PRE-APPLICATION CONSULTATION REPORT (PAC)

In support of a Full Planning Application for Development of Site for a Warehouse (Class B8 use) with ancillary offices, associated means of access, car parking, servicing and infrastructure, landscaping, ecological mitigation zone and ancillary works

Located at Site 5, Clywedog Road South, Wrexham Industrial Estate

DOCUMENT REFERENCE: FI005_004v2

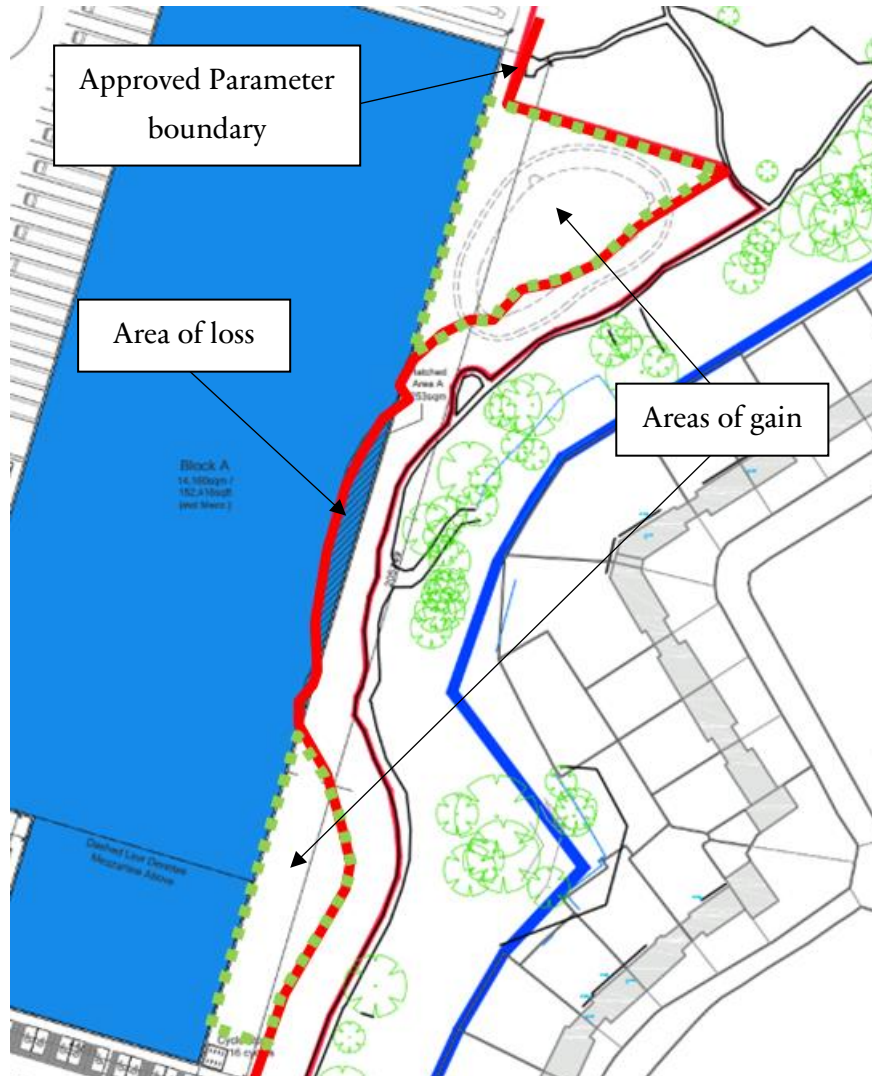
The development also encroaches on the buffer zone for the watercourse as shown on your drawings, and does not achieve the required balance between developed and undeveloped areas as set out in adopted Guidance Note 29 Ecology and Employment Development.

It is the view of the Local Planning Authority that the proposal represents an over development of the site in comparison with the indicative scheme shown on the outline application and raise serious concerns in terms of ecology and amenity.

- Comparison of the net impact on the approved buffer zone (permission P/2018/1087) and the revised buffer zone to this proposal will not lead to a net loss in area for ecological mitigation. The approved Parameters Plan allowed a considerable area of the site to the east of the planned building / curtilage to be developed which is now incorporated into landscape / ecology zone as illustrated below, outweighing the area

lost to the building footprint with a net gain of 1,414 sqm [1,667 sqm gain – 253 sqm loss]
